Subject: Project Enhancement and Refinement Document
Carlsbad Energy Center Project (07-AFC-6)

Carlsbad Energy Center Project (07-AFC-6) Project Enhancement and Refinement Document

Submitted by
Carlsbad Energy Center LLC

July 2008

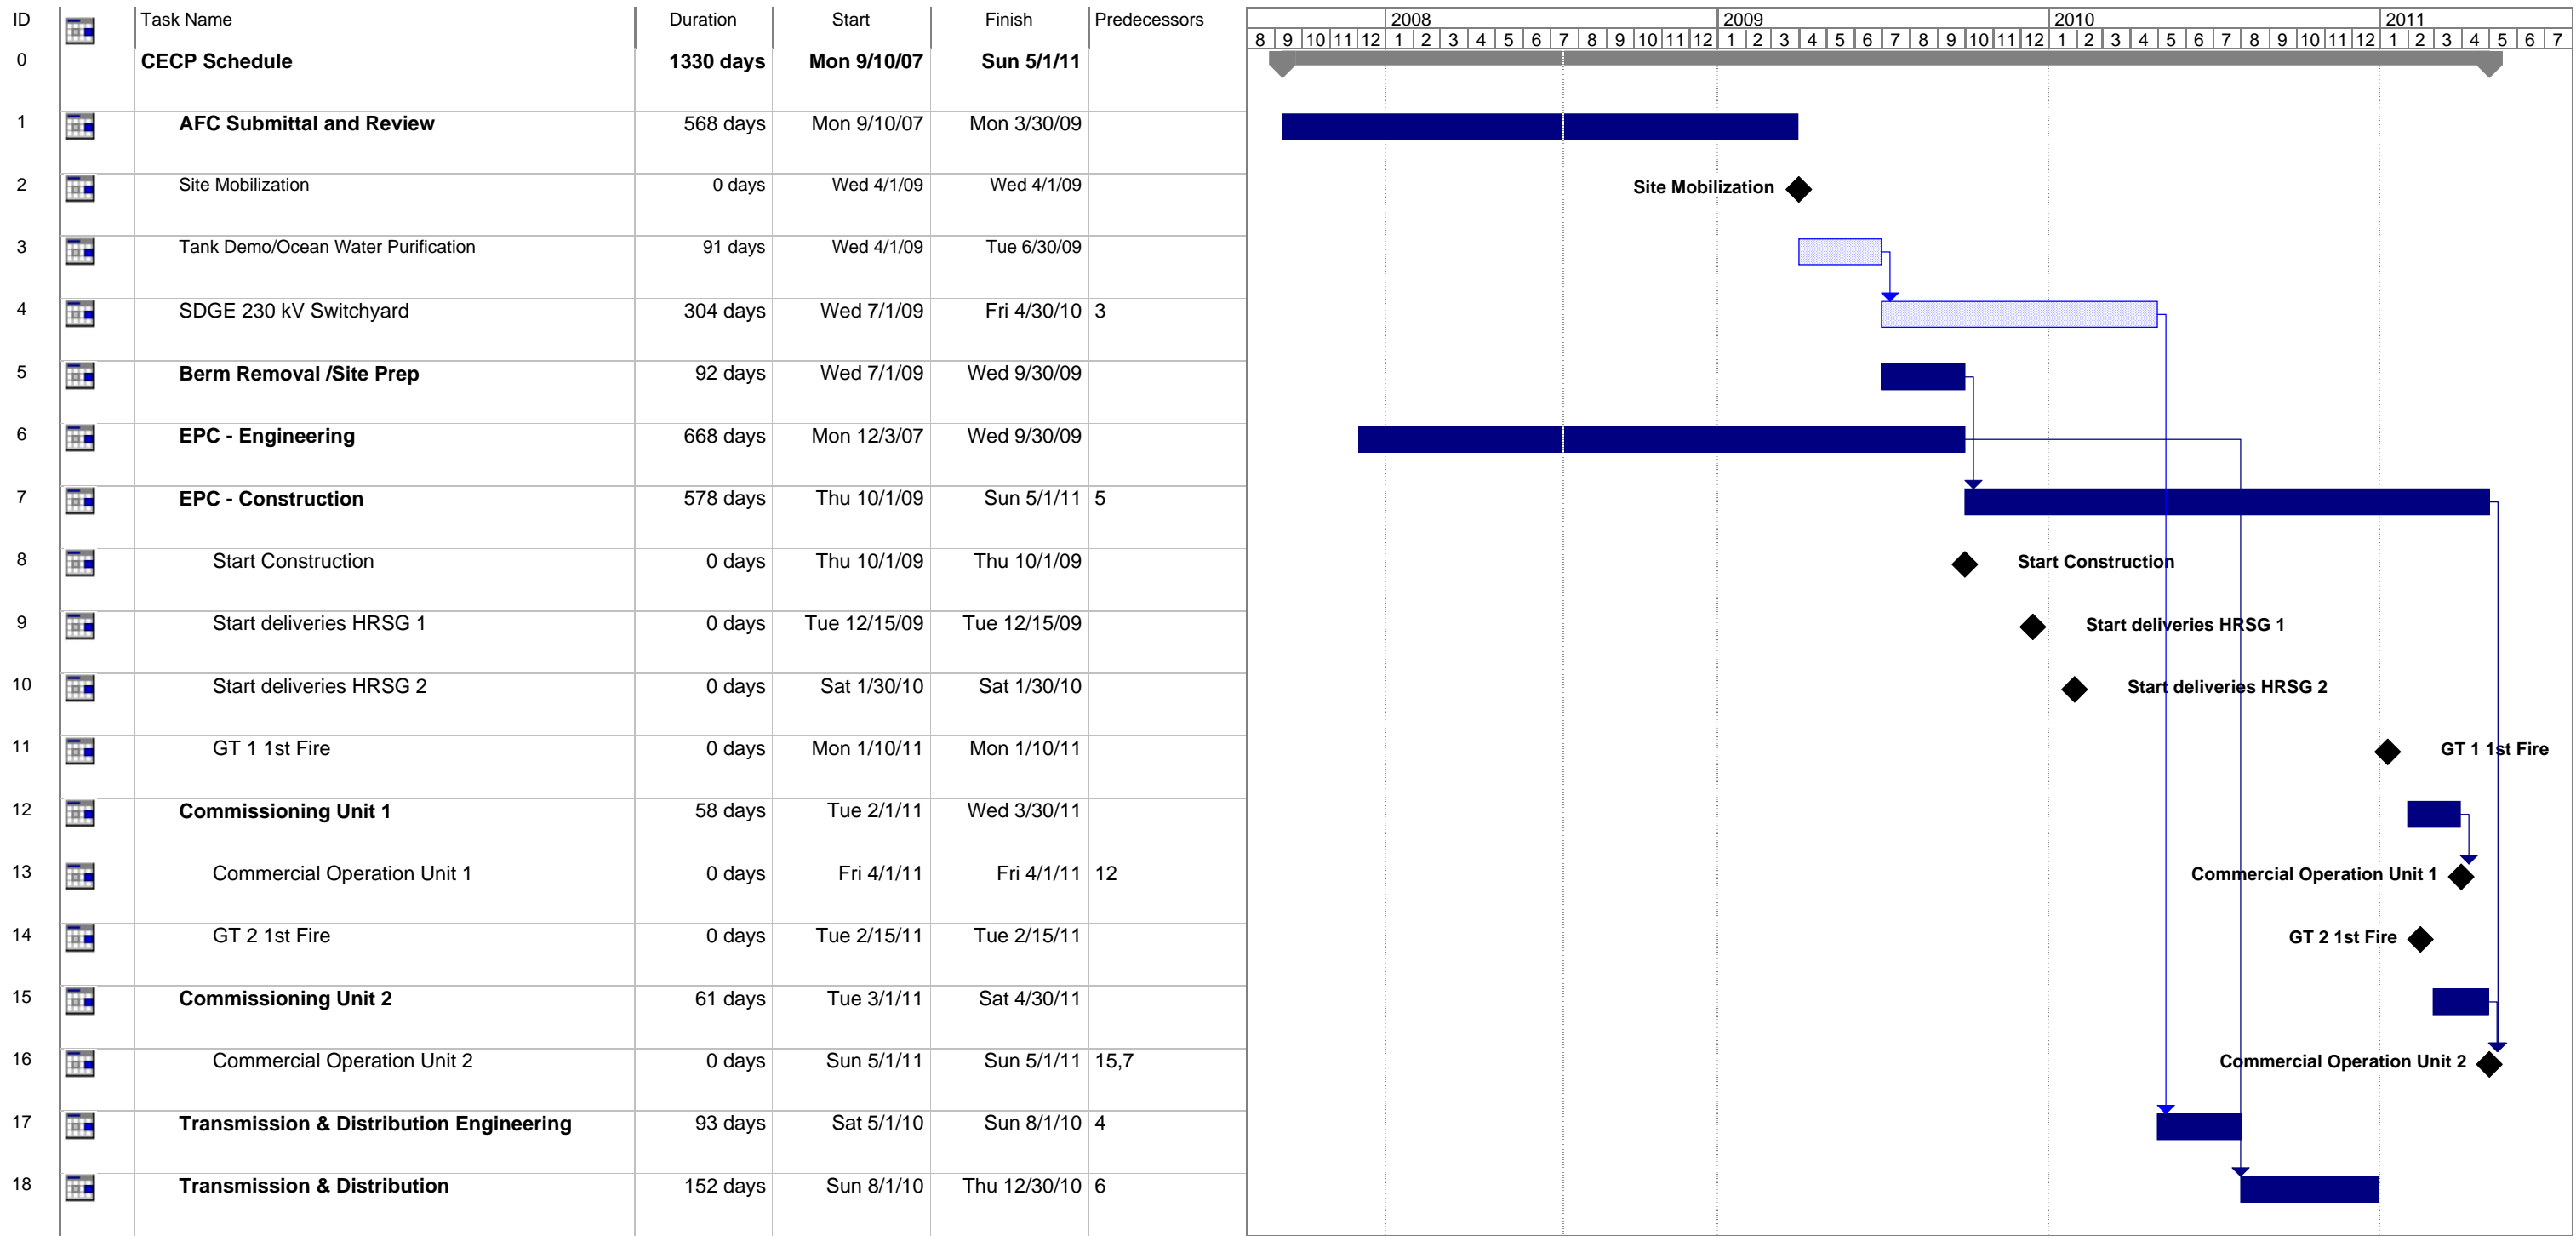
Revised Figure 1.3-1 shows a photograph of the CECP site prior to construction and a simulation of the CECP with the 139-foot-tall stacks after construction.

REVISED FIGURE 2.1-1
CECP PLOT PLAN
CARLSBAD ENERGY CENTER PROJECT
CARLSBAD, CALIFORNIA

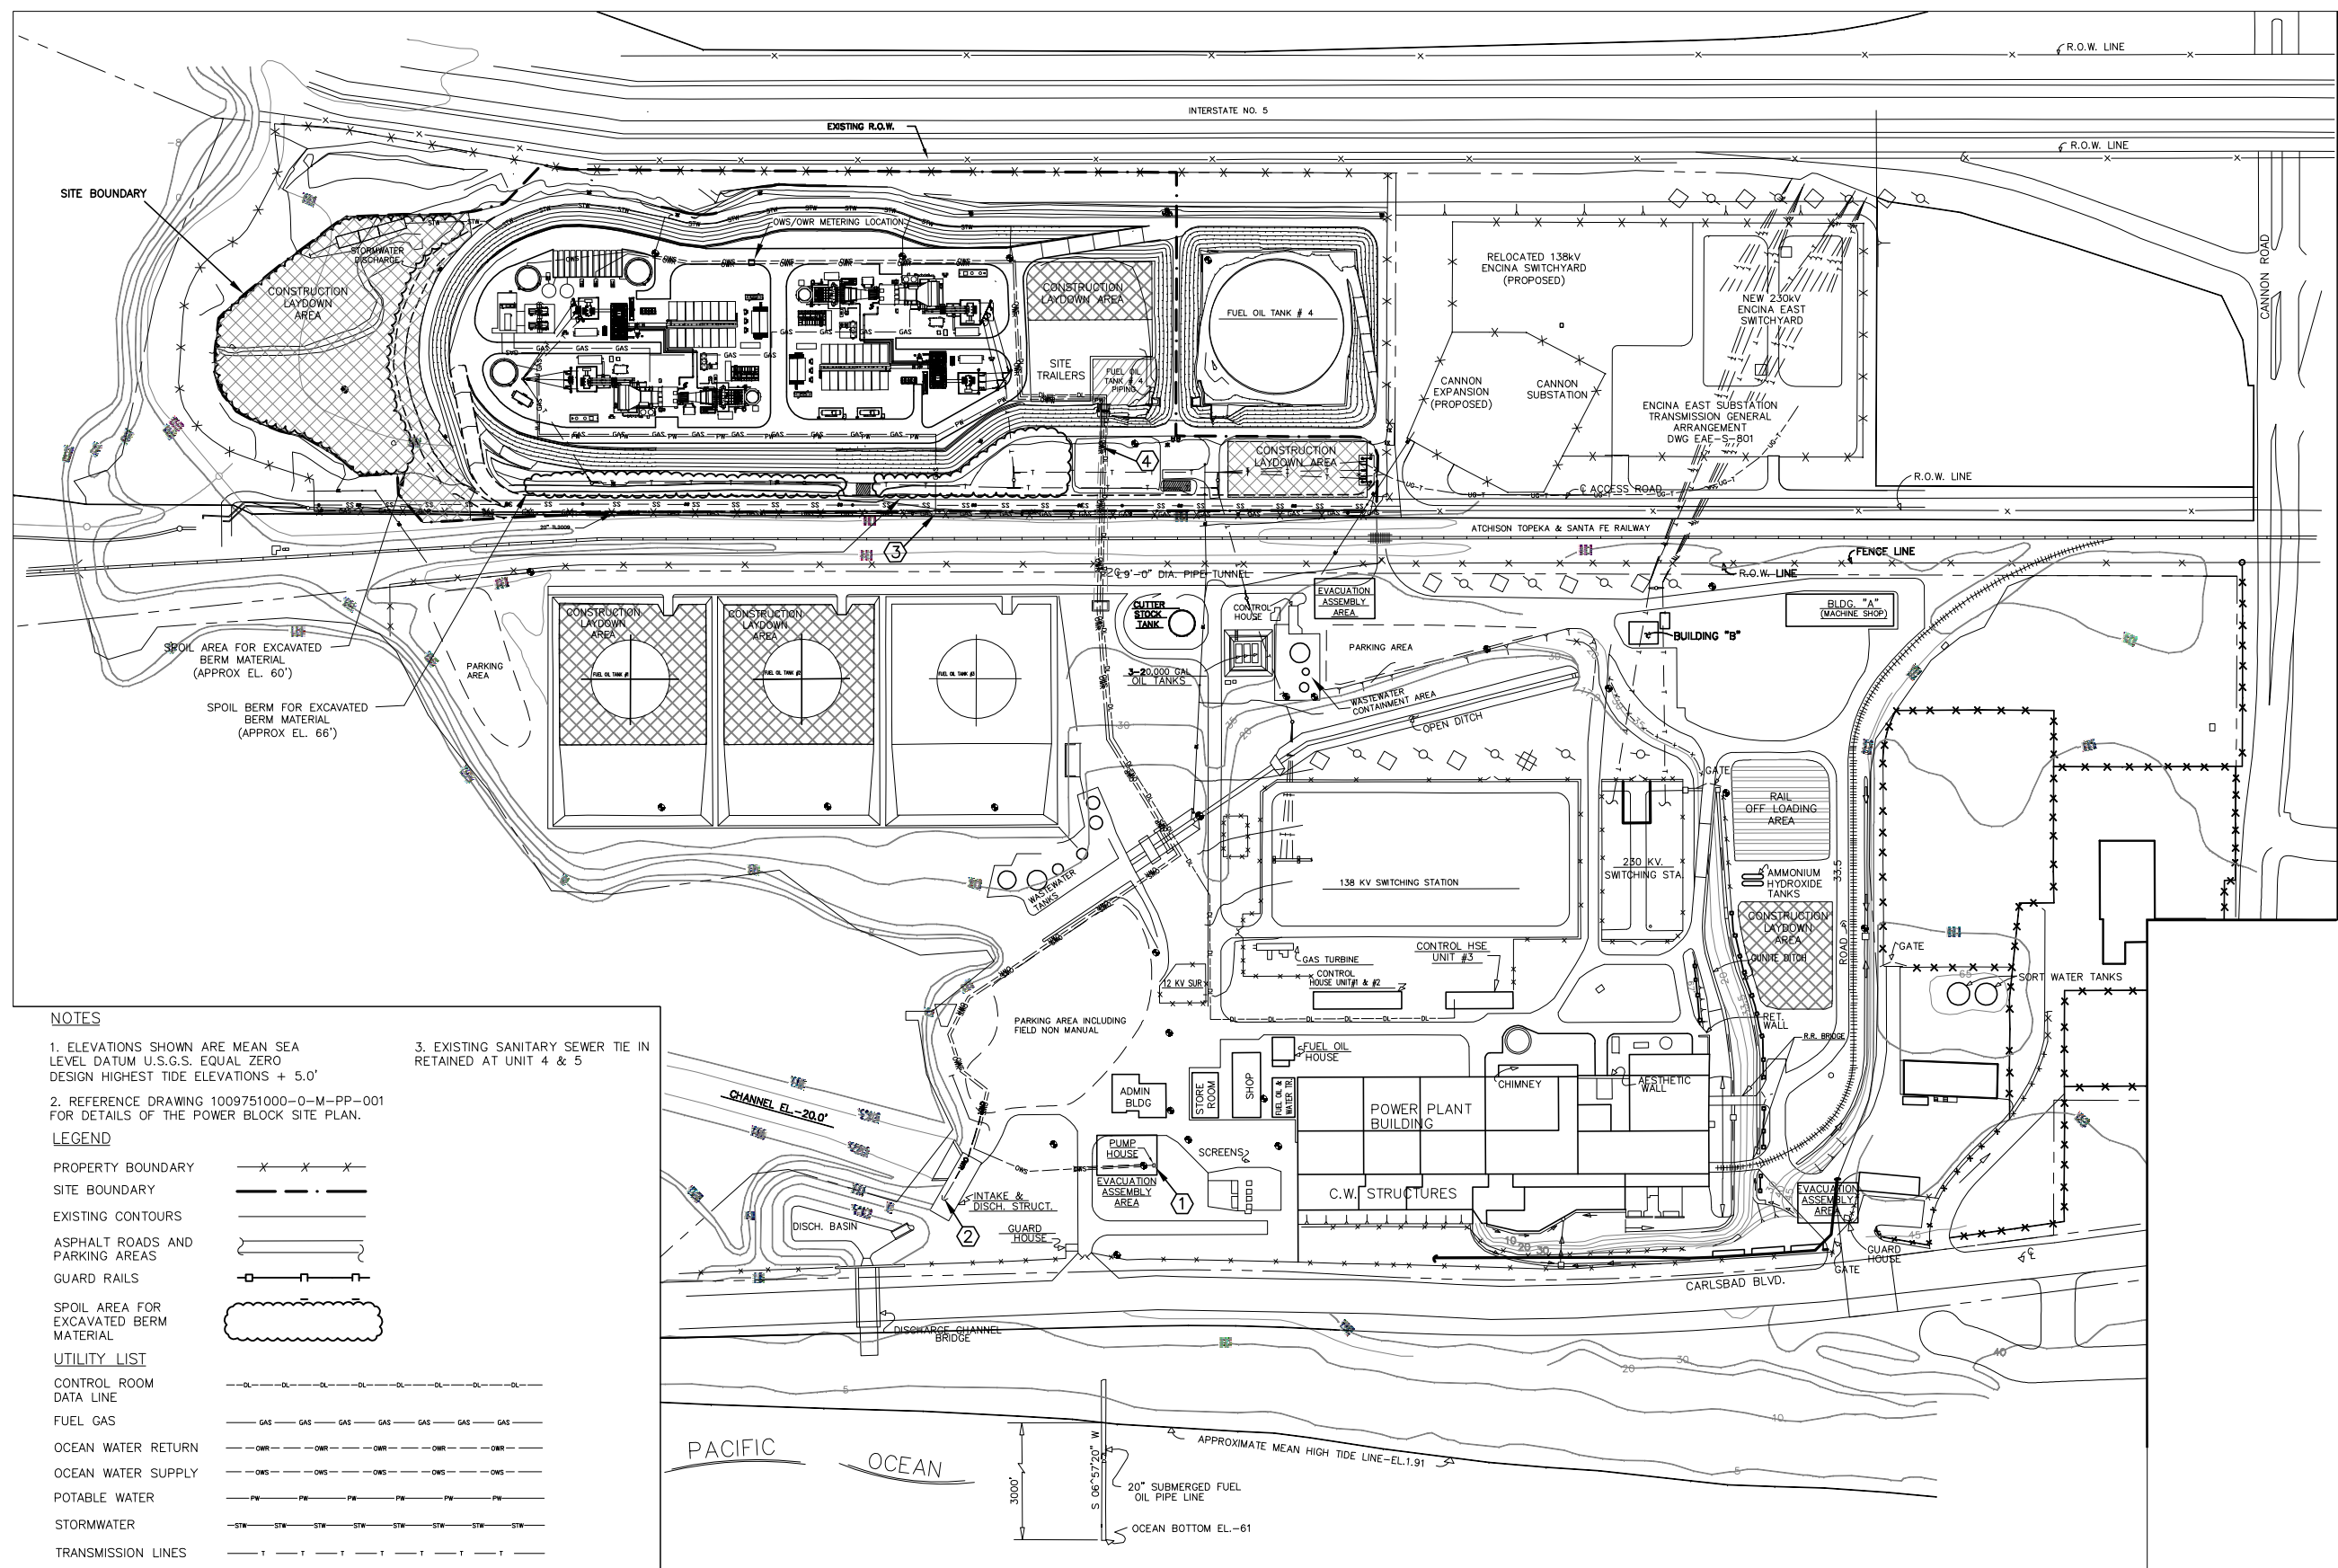
These four project enhancements and refinements do not change the overall design and operations of the components of the CEC power block from that described in Section 2.0 of the AFC. Revised Figure 2.1-1 provides the revised plot plan for the project, and Revised Figure 2.2-1 provides the revised site plan for the project. Revised Figure 2.2-2 and New Figure 2.2-2A provide the revised typical elevation for the CEC generating facility and the typical elevation of the new SDG&E 230-kV switchyard, respectively. New Figures 2.2-2B and 2.2-2C provide cross-sections of elevations for the CEC generating facilities and for the new SDG&E 230-kV switchyard, respectively.

The project enhancement and refinements include a new SDG&E 230-kV switchyard to be located on SDG&E property located between the railroad right of way and I-5 and south of the CECF site, as shown in Revised Figure 2.1-1 – CECF Plot Plan. The switchyard will occupy approximately 2.5 acres of the SDG&E property that is used for employee training and includes the existing SDG&E Canon switchyard. The 230-kV switchyard site lies about 750 feet north of Cannon Road.

REVISED FIGURE 2.2-1
CECP SITE PLAN
CARLSBAD ENERGY CENTER PROJECT
CARLSBAD, CALIFORNIA

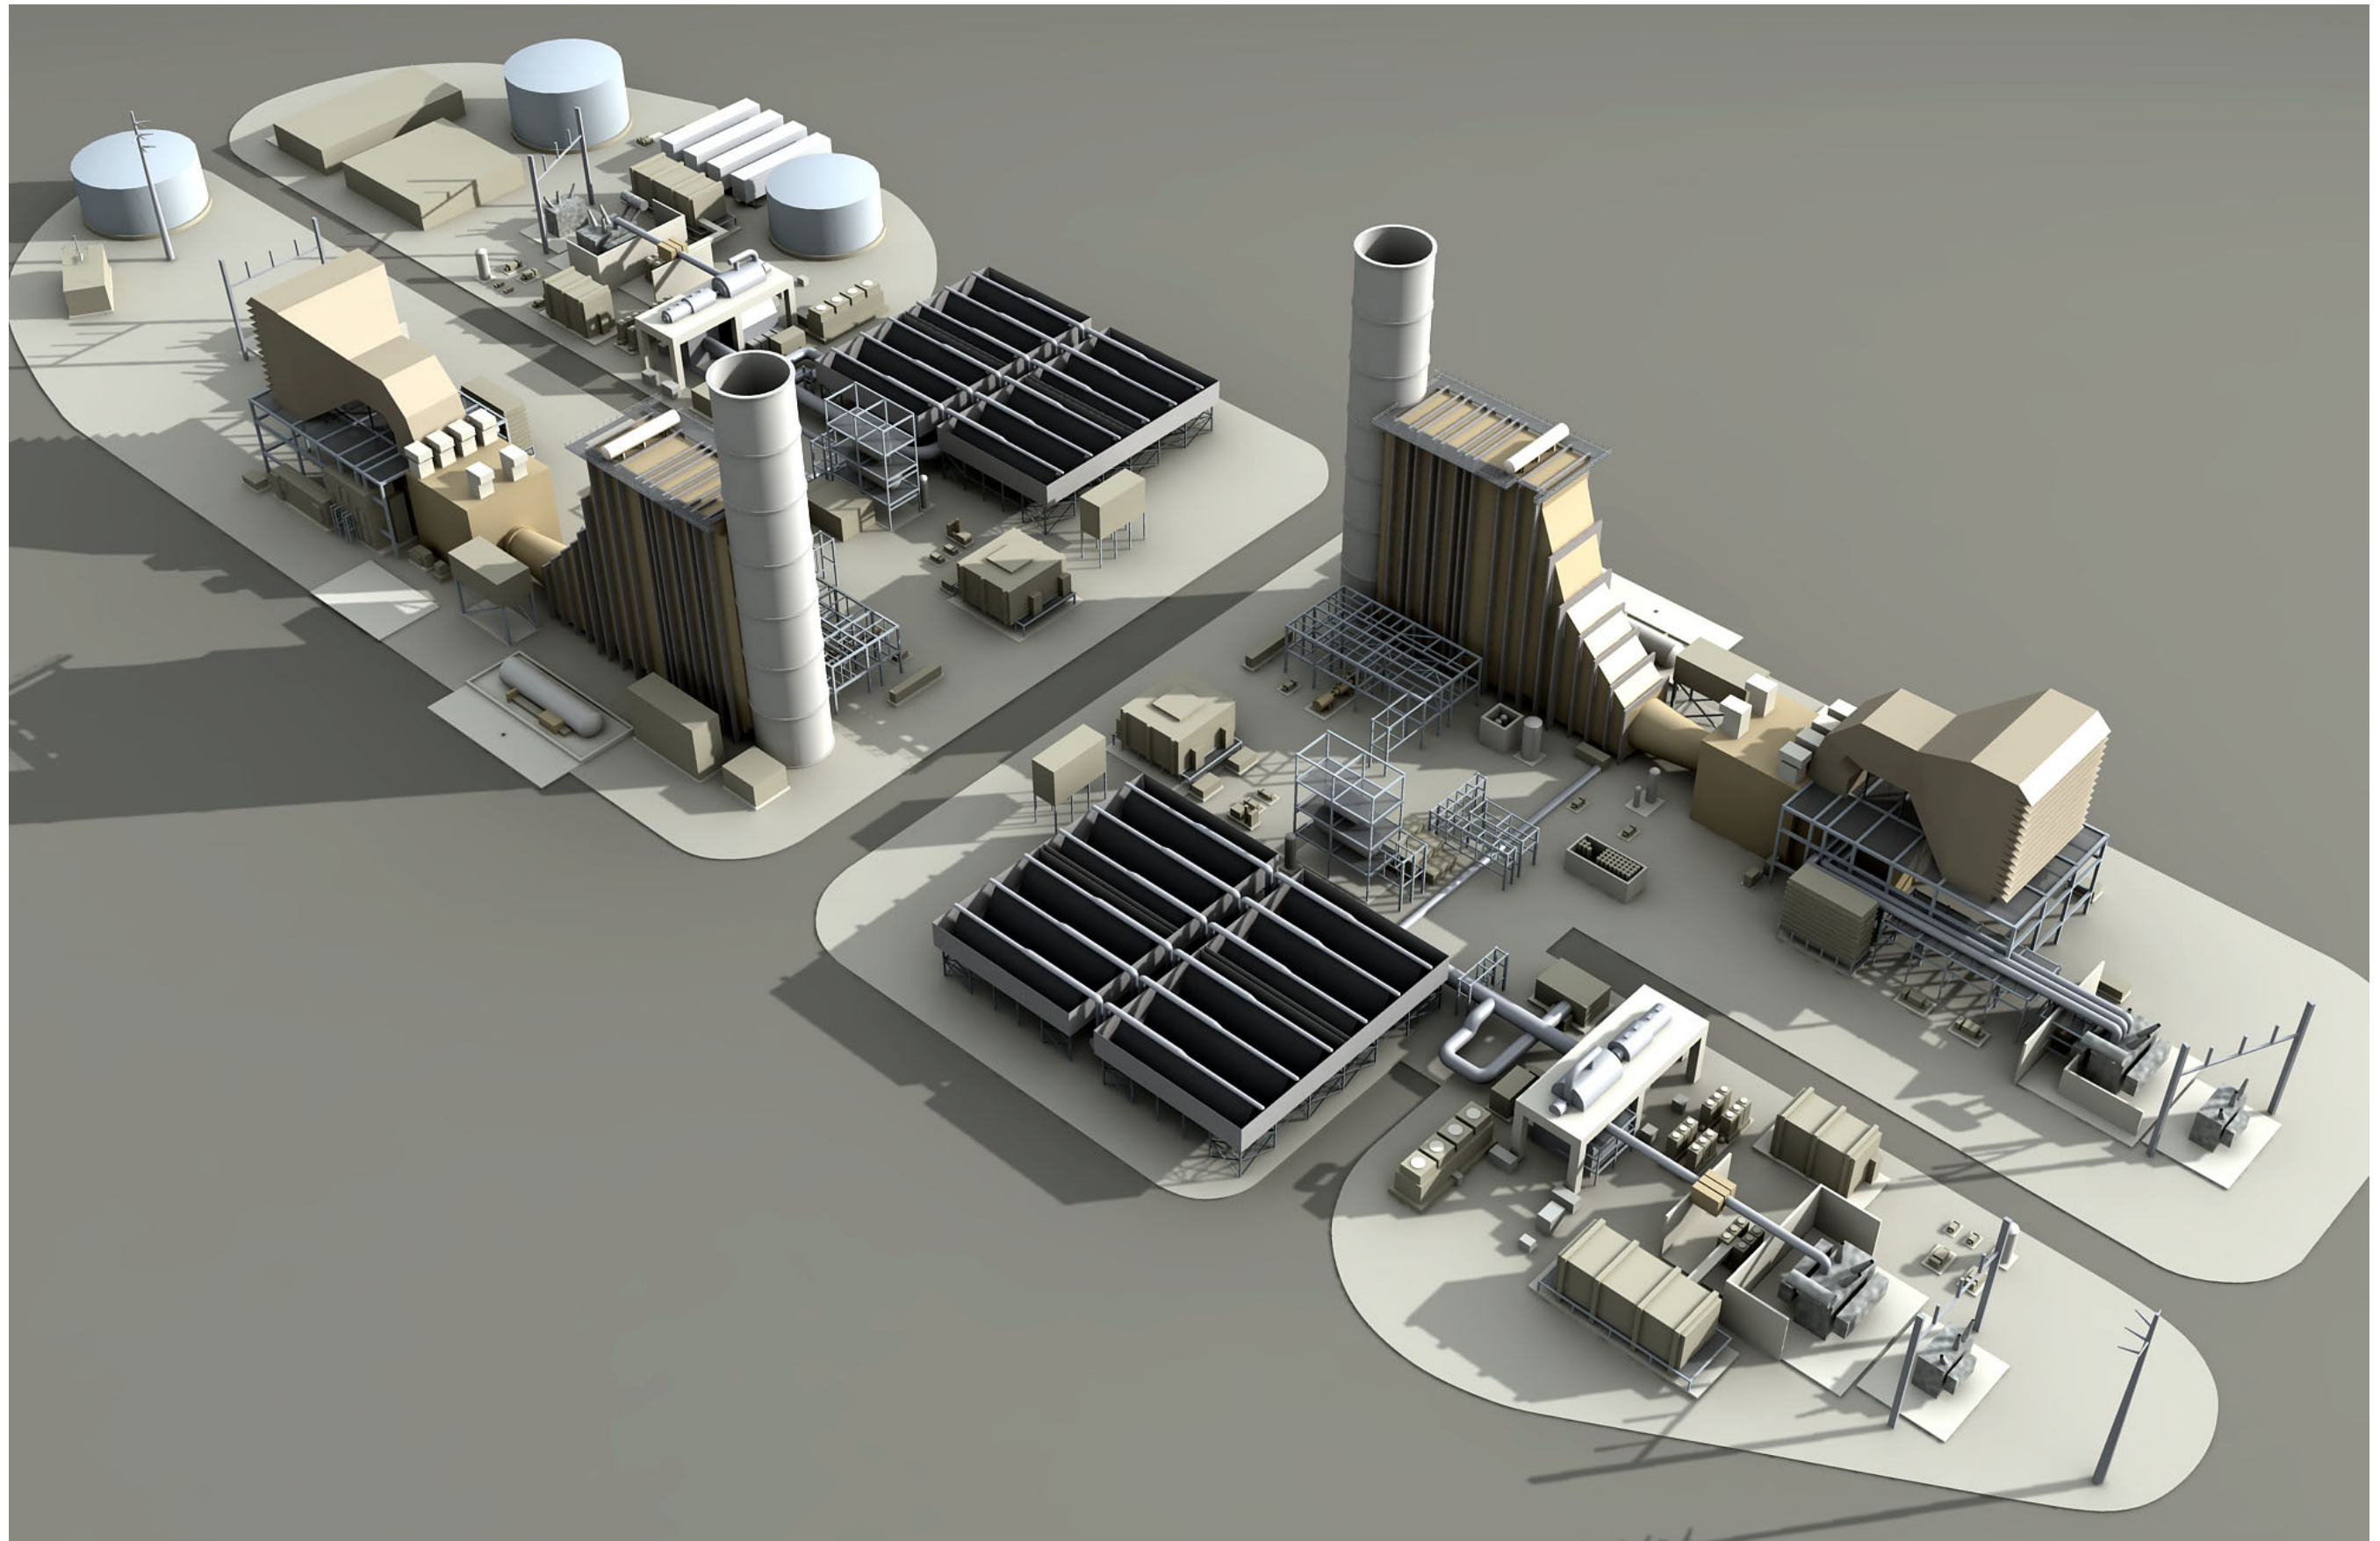
The location of the new SDG&E 230-kV switchyard is shown on Revised Figure 2.2-1. The new SDG&E 230-kV switchyard is located on SDG&E property south of the CECP site on

Note: Stack height is shown at 139 feet.
